# TRIUMPH

Number: 9-79  
Subject: Cylinder Head Gasket

Models: T140  
Date: January 1979

### CYLINDER HEAD GASKET

METAL CENTER TOWARDS CYLINDER HEAD

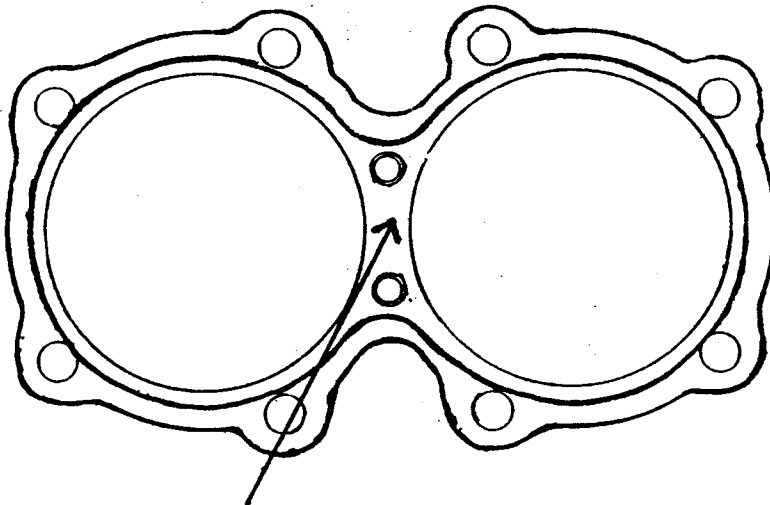
- 1) Ensure gasket is fitted correct way up, i.e. metal center towards cylinder head.
